**45-DAY EXPRESS TERMS
FOR
PROPOSED BUILDING STANDARDS
OF THE
CALIFORNIA DEPARTMENT OF PUBLIC HEALTH**

**REGARDING PROPOSED CHANGES TO
CALIFORNIA CODE OF REGULATIONS, TITLE 24, PART 2
CHAPTER 31 B
PUBLIC SWIMMING POOLS**

FIGURE 31B-8

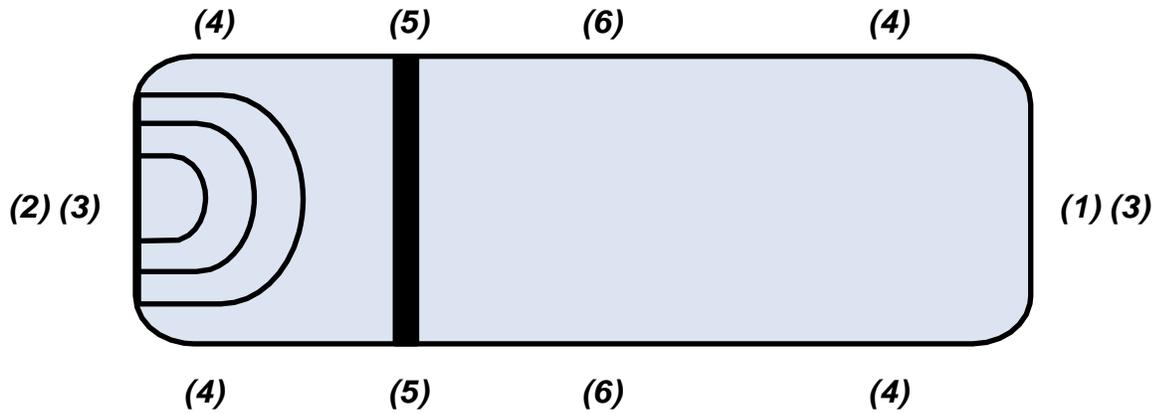
13) Add FIGURE 31B-8 as follows:

1. *Maximum depth.*
2. *Minimum depth.*
3. *Each end of pool.*
4. *Both sides at the shallowest and deepest part of pool.*
5. *At the break in the bottom slope between the shallow and deep end.*
6. *Along the perimeter of the pool at distances not to exceed 25 feet.*
